## Product Change Notification

**1. ECR #:** 25-38794-1  
**Notification #:** 801

**3. Series:**  
• QFS - QFS .635mm STRIPS

Before Change

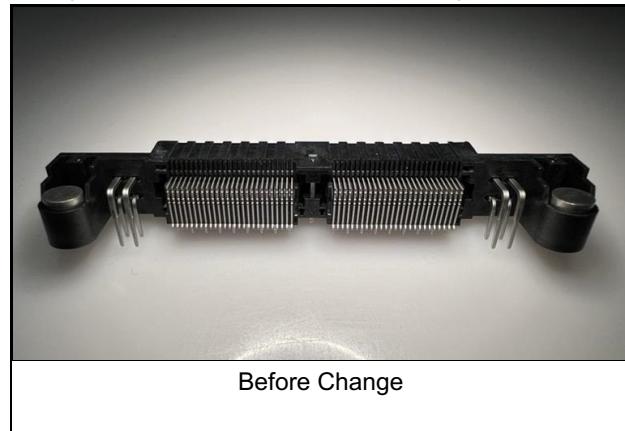
This change adds plastic housings to power pins on QFS-D-RA-PCX assemblies to improve auto-placement capability.

Changed product will have plastic housings mounted on each bank of power pins.

After Change

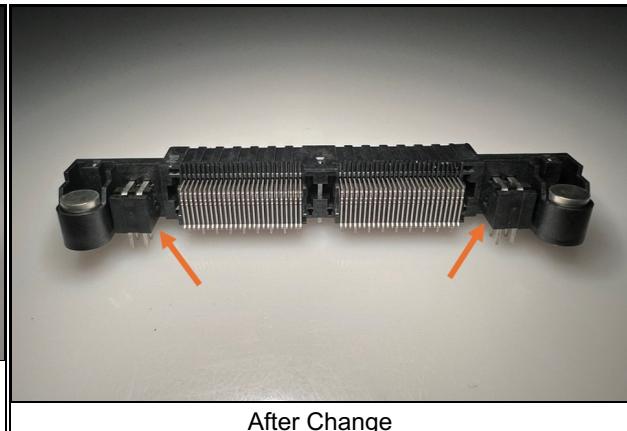
- Form - Two additional plastic housings have been added, one on each bank of power pins.
- Fit - Keep out areas on the PCB footprint around power pins are now required. The Samtec QFS-RA footprint recommendation will be updated to reflect this change.
